TECH BULLETIN

001
03/75

SUBJECT: Long to Short Cylinders Change - Piston Pumps

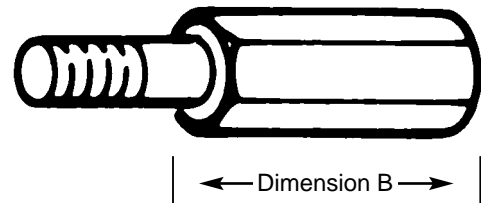
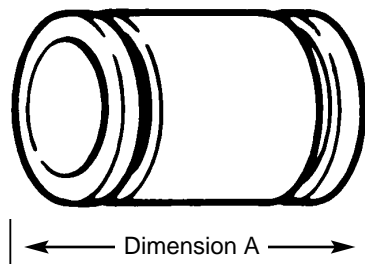
Early production **10 Frame** pumps were produced with long cylinders. Production was then changed to the short cylinders. The long cylinders required a long cylinder bolt. The short cylinders require a short cylinder bolt. **The long and short cylinders and bolts cannot be interchanged and must be replaced as a set.**

As the long cylinders and bolts are no longer available, it is necessary to convert to the shorter cylinders and bolts.

Model 623 and 1010 pumps prior to 5740101 had the long cylinders. Model 820 pumps prior to 0740101 had long cylinders.

OLD	NEW
<u>Dimension A</u>	Long Cylinder 2.164" (55 mm)	Short Cylinder 1.69" (50 mm)
	Chrome Plated	Chrome Unchromed
	<u>Pump Model</u> <u>Part No.</u>	<u>Part No.</u> <u>Part No.</u>
	520 —	28763 29045
	623 27349	28342 28776
	820 27423	28340 28778
	1010 27416	28341 28780
<u>Dimension B</u>	Long Cylinder Bolt 3.05" (77.5 mm)	Short Cylinder Bolt 2.75" (69.9 mm)
	<u>Pump Model</u> <u>Part No.</u>	<u>Part No.</u>
	All models 27351	43047
